This brochure compromises of the proposed design changes to Block A and Phase 1A, which are submitted as a non material amendment to Reading Borough Council.

Block A forms part of a much wider scheme relating to the redevelopment of the St MartIn's Precinct in Caversham which was granted planning permission on 31 March 2015 with Reference No.140997. Block A was redesignated as Phase 1A in a Deed of Variation to the S106 agreement dated 20 April 2017.

3.0 Proposed revised design comparison

Gate Design / Construction

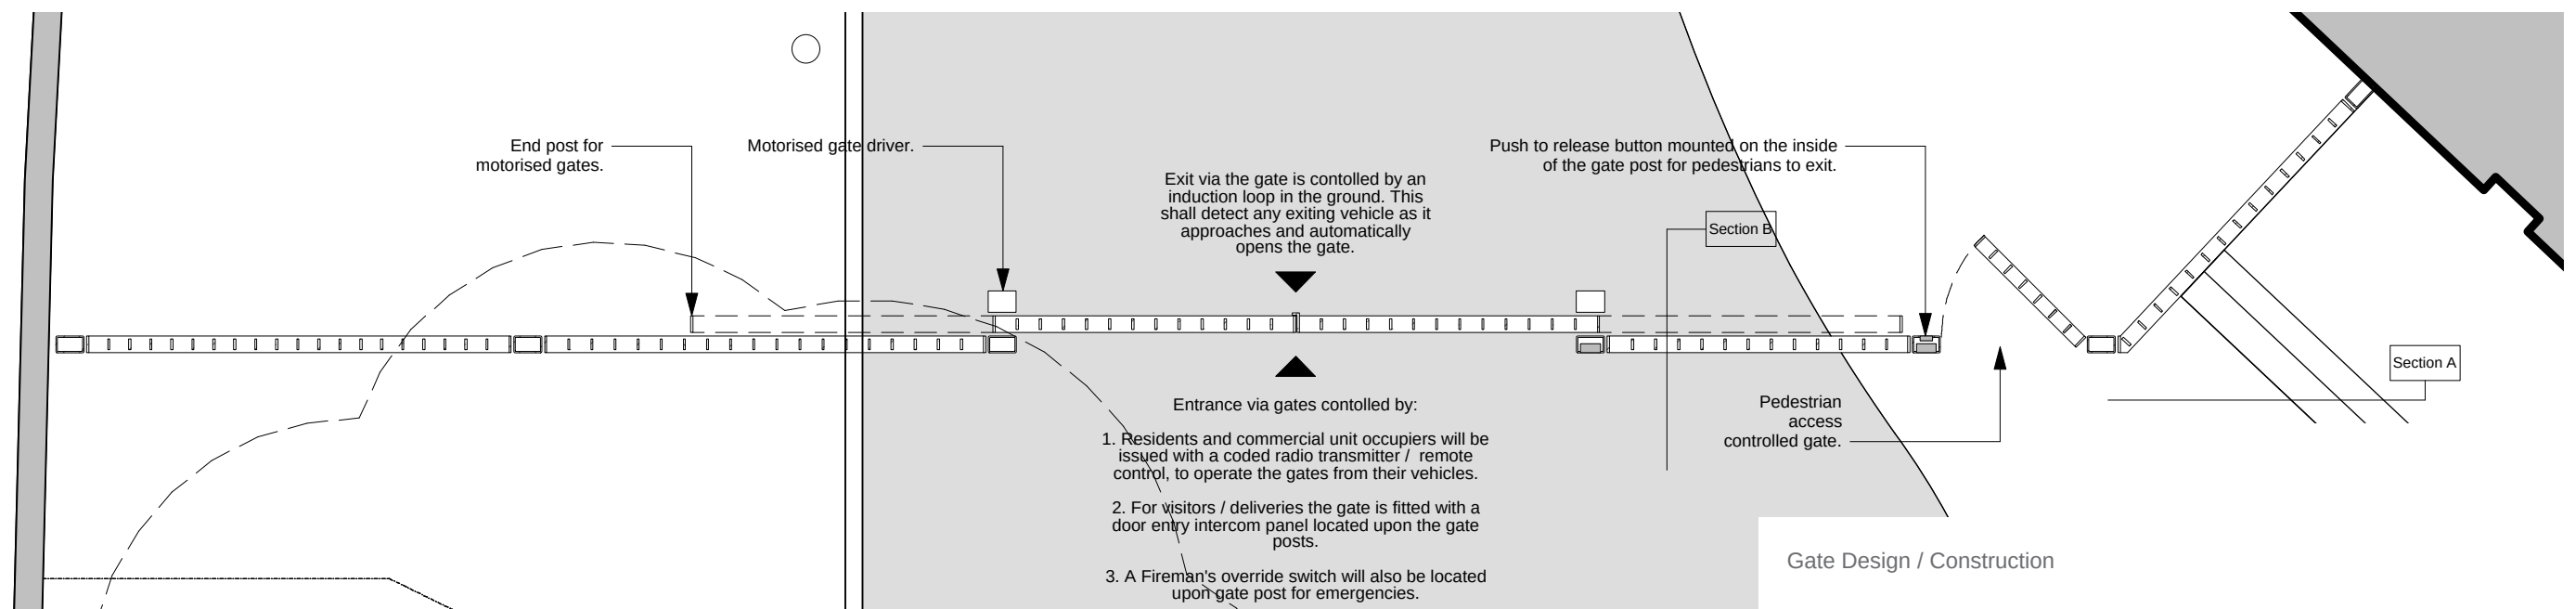
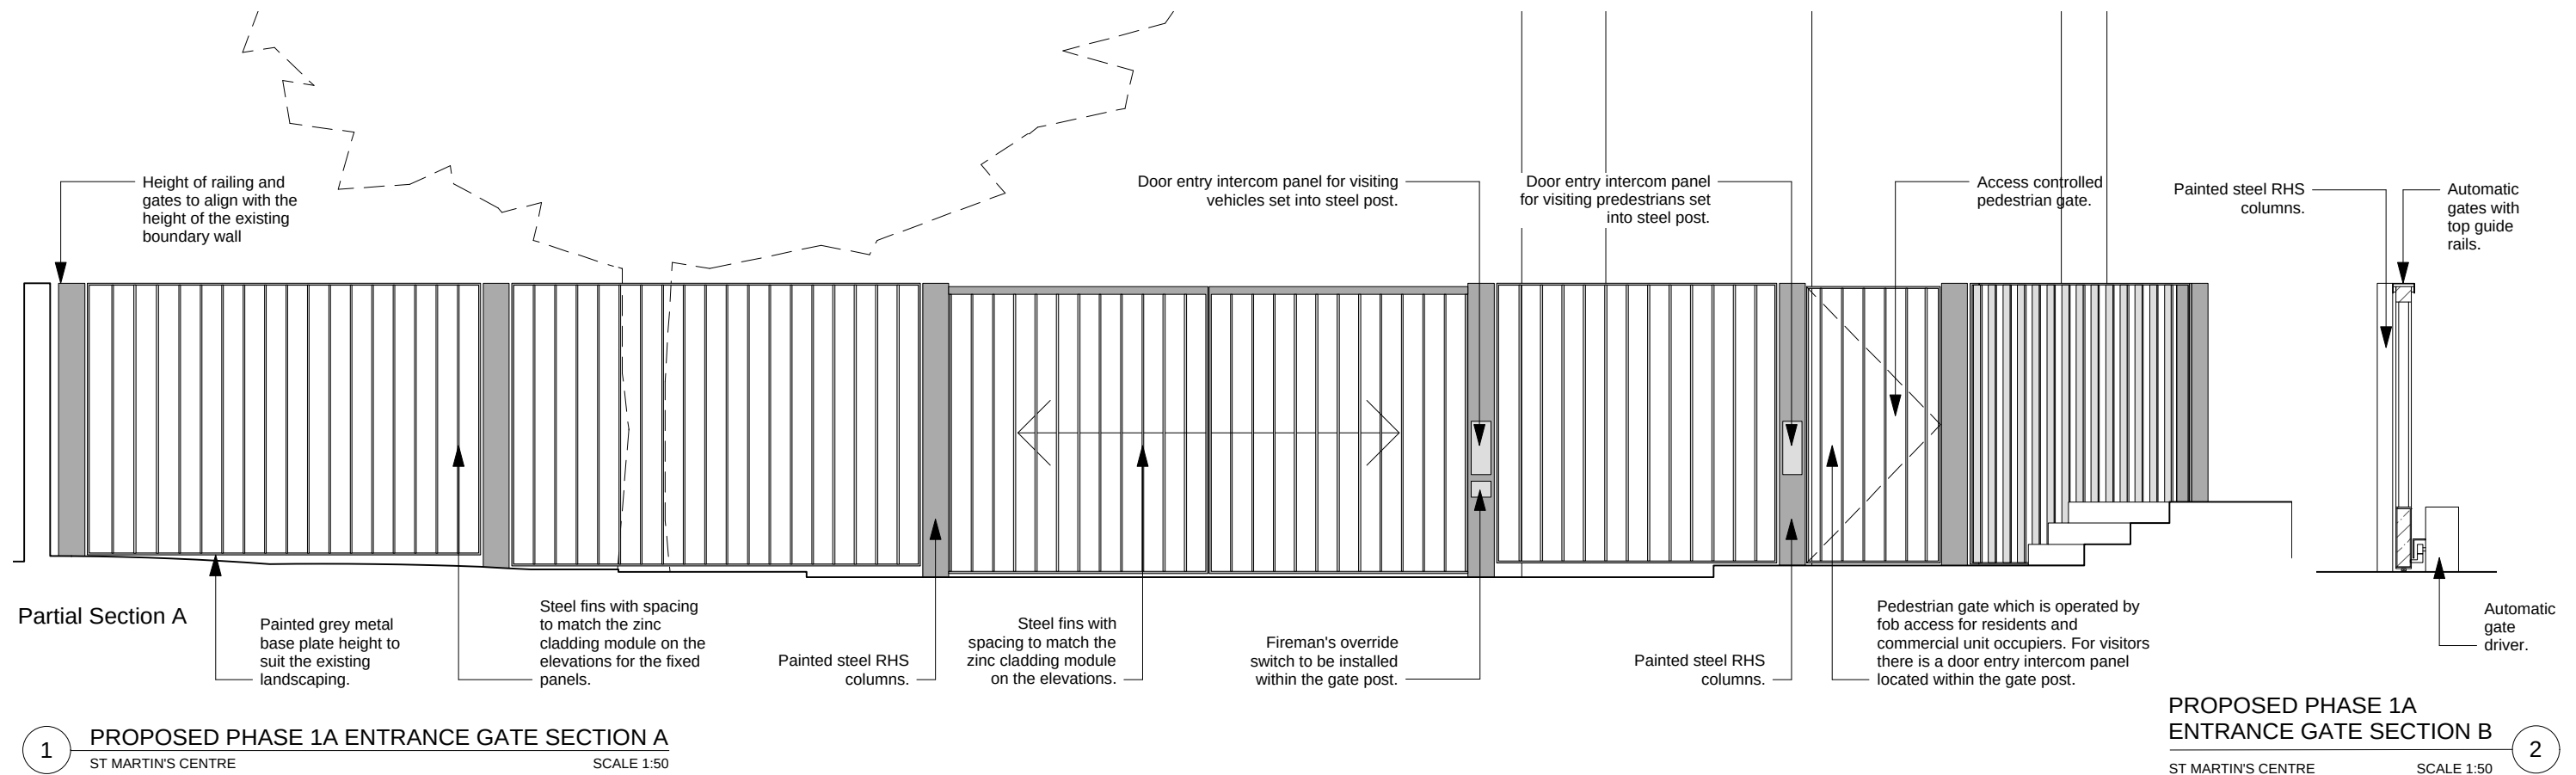
Following discussions with the arboriculturist, a design has been produced that enables the gate and foundations to be constructed in locations using methods that will not impact on the existing Lime tree that is to be retained. Above are the details that the arboriculturist has approved and which will be addressed in more detail in the tree protection plan, which is to be submitted by FLAC in relation to Condition 8 of the Planning Permission.
